Council Assessment Panel

### Wednesday 17 February 2021, 9.30 am

Application No.	580/270/20		
Applicant	Kings Baptist Mt Barker		
Subject Land	Lot 1000 in D120098, CT 6216/537,		
	41 Bollen Road, Mount Barker		
Ward	Central		
Proposal	Kings Baptist Grammar School - Stage 1:		
	School Building and Early Learning Centre, including associated		
	Decking, Shelter, Pergolas, Car Parking, Landscaping, Fencing,		
	Retaining and Infrastructure		
Development Plan	Mount Barker District Council – Consolidated 8 August 2017		
Zone	Residential Neighbourhood		
Form of Assessment	Merit		
Public Notification	Category 2		
Representations	1		
Persons to be heard	1		
Agency Consultation	Nil		
Responsible Officer	Derek Henderson		
Recommendation	Development Plan Consent

Figure 8 - WGR report showing upstream developments

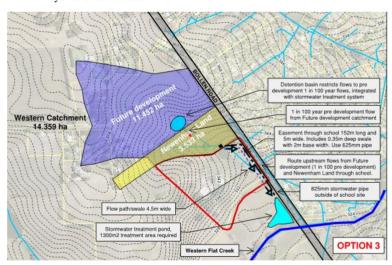
- 'Figure 8 – WGA report showing upstream developments' in section 2.4.2 shows superseded catchment areas. Adopt most recent upstream catchment information (refer attached revised WGA catchment plan), thanks for sending through updated catchments, note our SMP has been based on no upstream development IE the 1% per development flows are coming onto our site, this will be reduced if the development goes ahead and captured this flow and directs around our site, when upstream development is confirmed we will check our design calculations

'Figure 8 – WGA report showing upstream developments' in section 2.4.2. indicates detention basin in
upstream future development (11.452 ha area). Note that the basin is not being implemented in future and
detention is not to be adopted in any modelling (update models to reflect correct arrangement), as above,
current modeling is assuming no development to the north

Figure 10 - pre-development site catchment plan (site layout shown indicative only, refer architect plans for current)

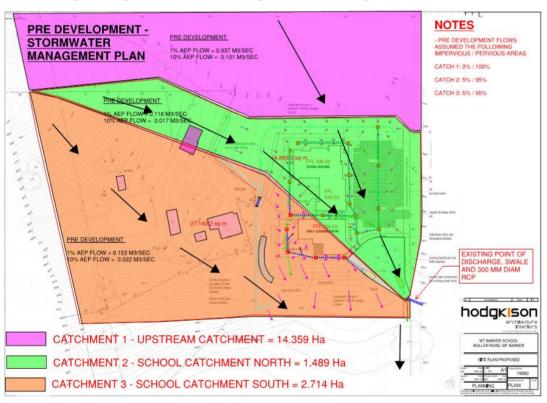
- Further to the above point, 'Figure 10 – pre-development site catchment plan' in section 4.1.1. doesn't appear to include correct catchment area contributing to the site. Please update to reflect correct area of catchment contributing and amend model to suit, refer above. Note the 14.359Ha upstream catchment came from the original WGA report

Figure 1 = Drains outputs - 1% AEP with pipe restricted to 0.15m diameter (left) - 10% AEP with pipe restricted to .15m diameter (Right)

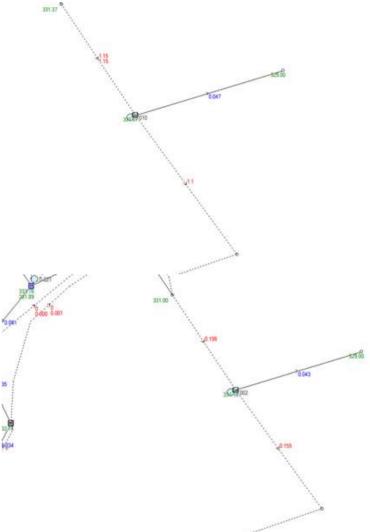
If required, a 150mm restriction gate or orifice can be installed to the existing 300 diameter pipe to better control flow through this pipe, restricting this pipe to 150mm will reduce flows to 0.047m3/sec 1% AEP and 0.043m3/sec 10% AEP (pre dev was 0.188m3/sec / 0.115 m3/sec respectively).

Figure 2 - ARR Regional Flood Frequency - check

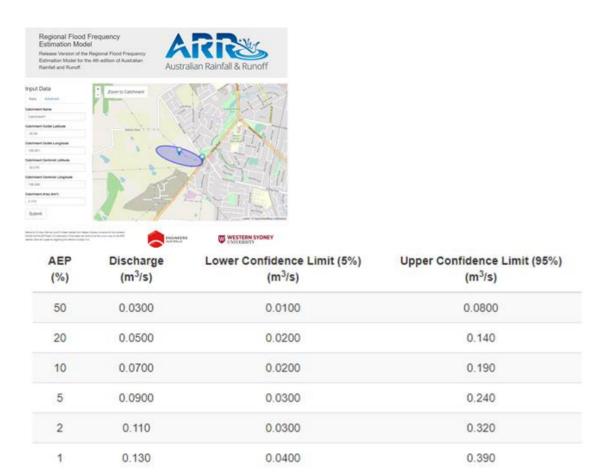
- In regards to catchment 1, Section 4.1.2.1. mentions 'Stomwater from this catchment is conveyed across the development site in a gulley that runs through the north-eastern corner of the site, a man-made swale captures the flow from this gully and directs the flow into a 300mm diameter pipe...'. Is this correct? Yes this is the current flow path (pre development) Both concept and detail design drawings indicate it flows via pipe through the carpark. Correct, post development. Note, as per findings from dot point 1 & 2 above, with the correct external catchment considered, will the pipe through carpark have sufficient capacity for interim bypass solution? It has been designed for pre development 1% AEP Also, would upstream flows through carpark swale/bio-retention system also be problematic (or is it being contained in pipe only?). the northern development (by others) is being contained in the pipe, and will not discharge onto our site. Note further that a temporary swale situated within 5m easement on eastern boundary (prior to installation of 1% AEP pipe) is an acceptable option as an overland flow path with the appropriate design/treatment, the School site will handle any pre development flows (le assuming the northern development does not proceed)

Figure 3 - Possible update required is connecting to 1050 main

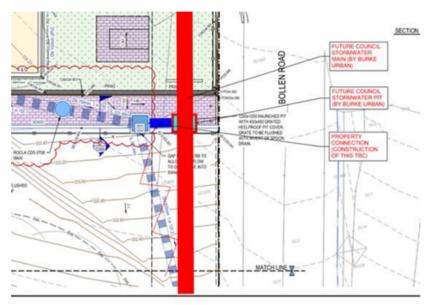
Below is a possible connection if the Newnham development proceeds, this will be updated once confirmed ok.

Figure 4 - Max extent of ponding

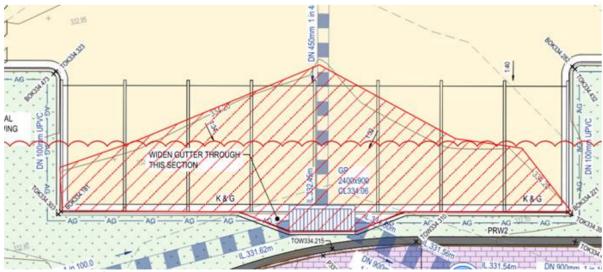
Civil Works Concept Plan nominates an area for basin/ponding in the carpark, although the extent of pooling runs perpendicular to the site levels with 2.416m height difference (RL 336.081-333.665). Please provide commentary on how the water is to be detained given the site grades and whether this pooling area is actually being adopted for detention purposes, these 2 pits as show are modelled as sag pits, the norther pit, will be graded to create a small depression, the southern pit will be against the 150 kerb

As mentioned, this will pond against the 150mm high kerb, this has been modelled in DRAINS.
